NOTICE OF PUBLIC MEETING

Governmental Body: Van Meter Planning and Zoning Commission

1. Call to Order/Roll Call
2. Approval of Agenda
3. Approval of Minutes from June 18, 2014
4. Review and provide the City Council with a recommendation on the Integrated Sales facility expansion at 527 Main Street.
5. Adjournment

Plans For INTEGRATED SALES INC. OFFICE EXPANSION

A1.1

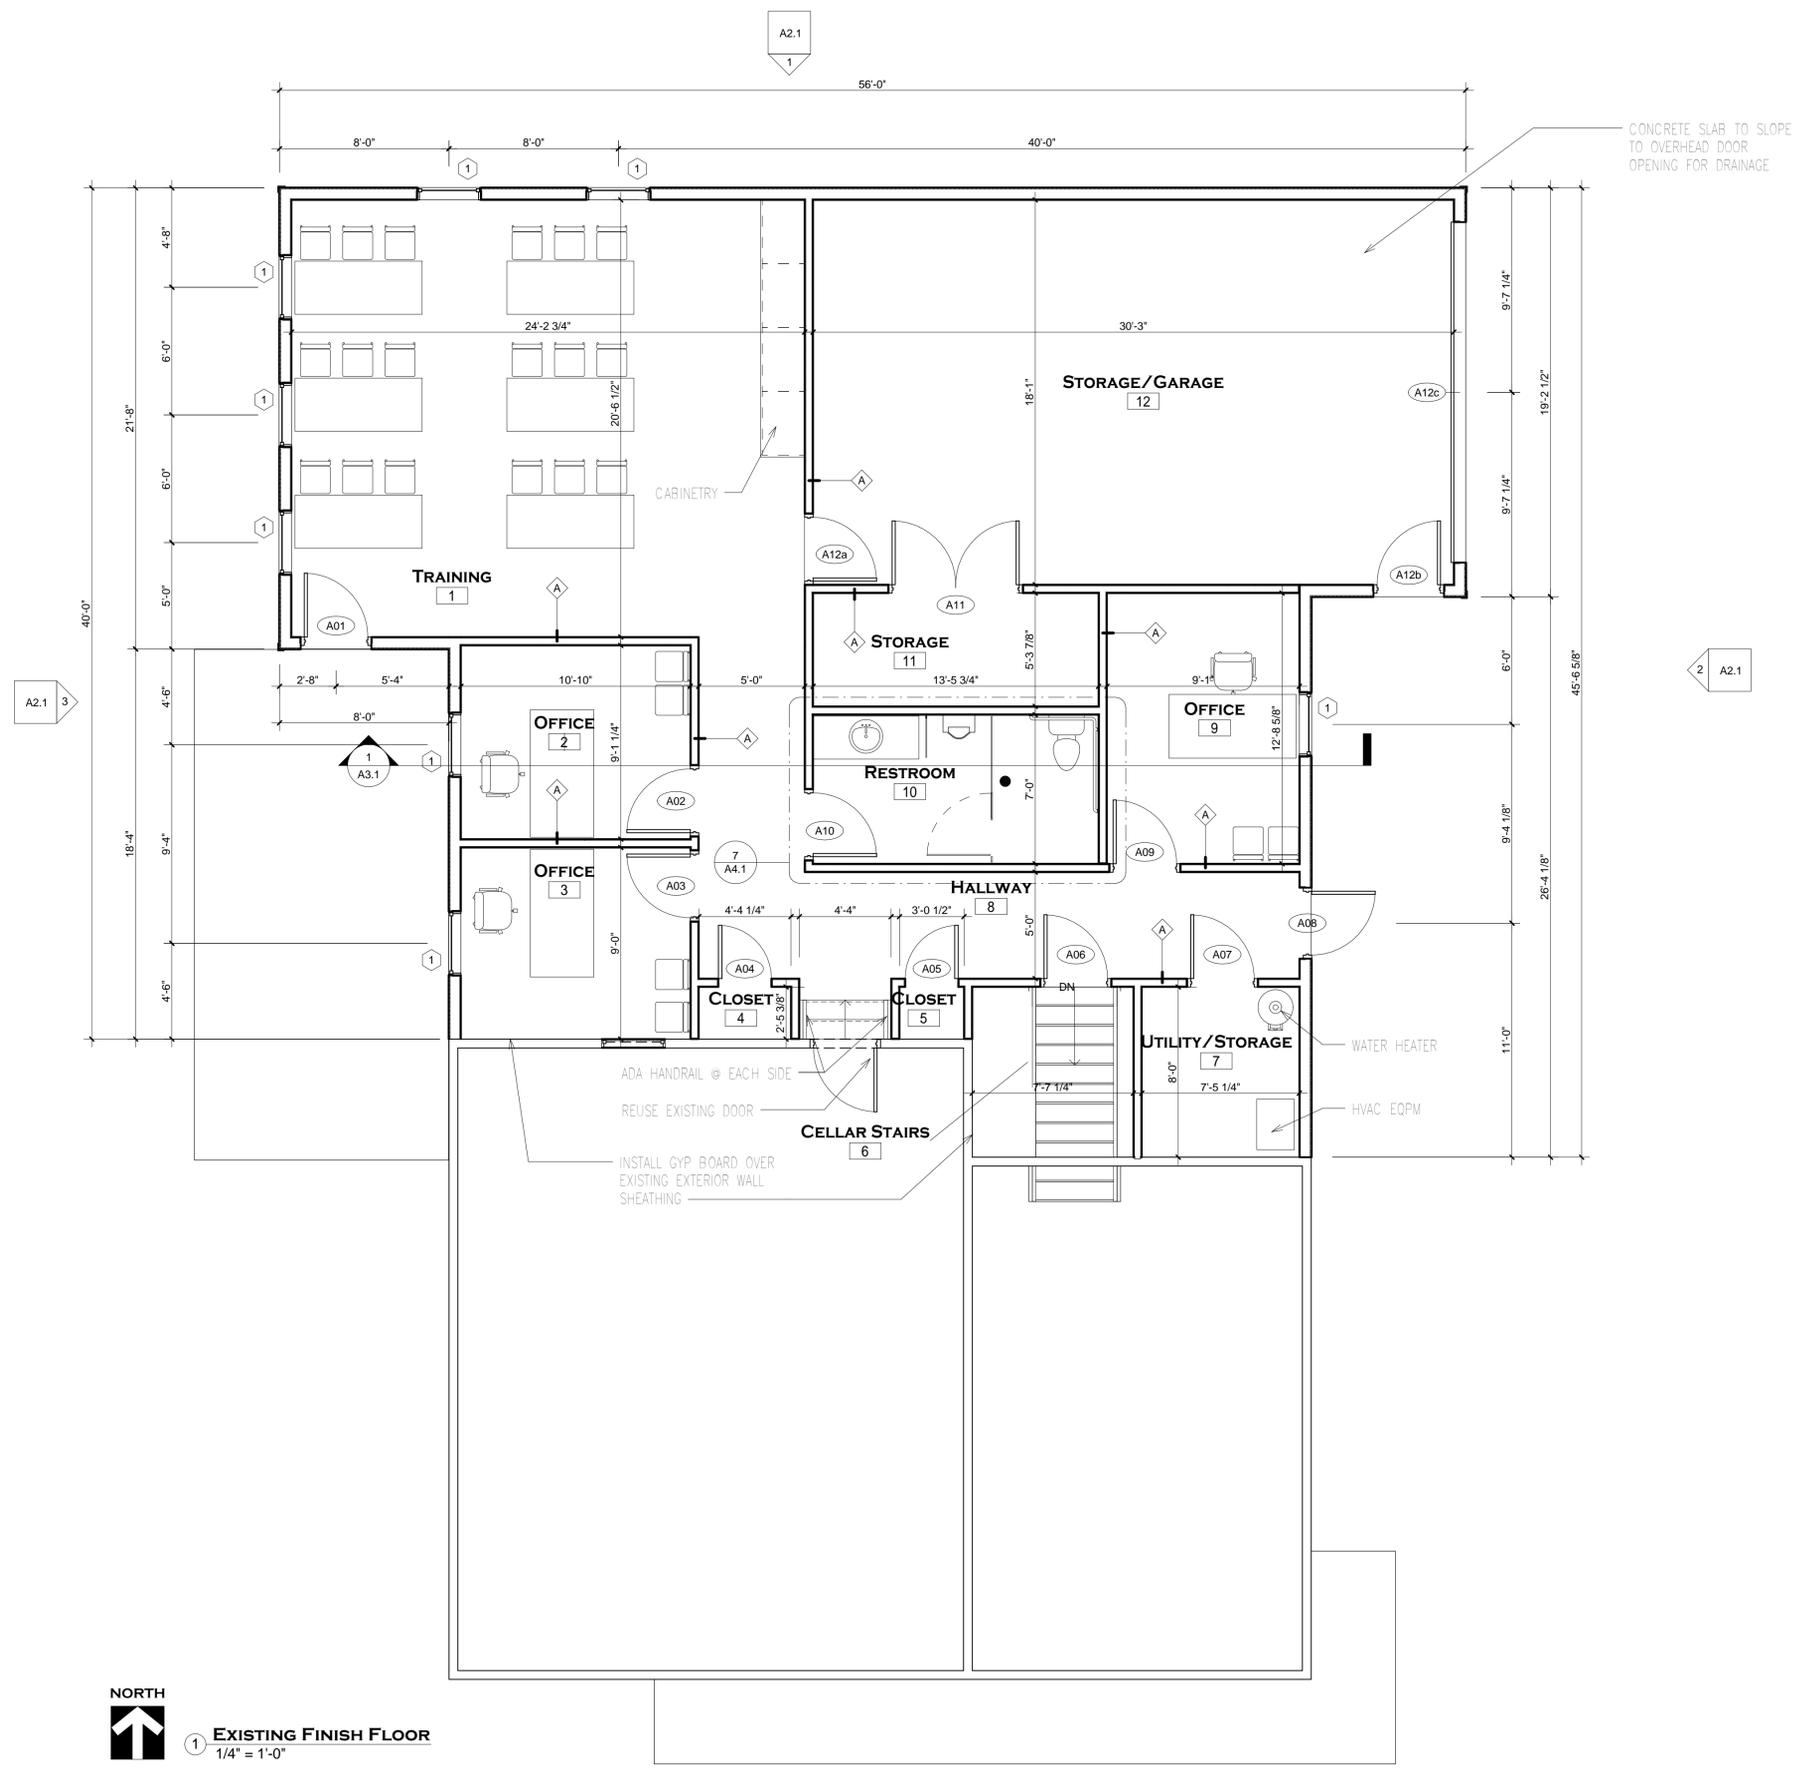
The only issue may be the rear yard set back. I believe this parcel is in a C-1 district. The rear yard setback is 35 feet and they are showing 25 feet. The rear yard can be decreased by one foot for each foot the front yard is increased over 25 feet. I am not sure they have the lot lines exactly correct as the south lot line would normally be at the north edge of the sidewalk and not the south edge. However, the county assessor map shows the line in the middle of the sidewalk.

The lot is 132 feet north to south and the expanded building scales 65 feet. The combined front and rear setback is 60 feet (35 +25). That total is 125 feet indicating there is 7 feet to spare. I think we need to confirm the maximum north south dimension of the expanded building is not more than 72 feet. If so the combined setback would be at least 60 feet and would be acceptable even without finding the exact location of the lot line.

It sure appears the building is less than 72 feet so I think everything is met, but it makes sense to have them confirm the building size.
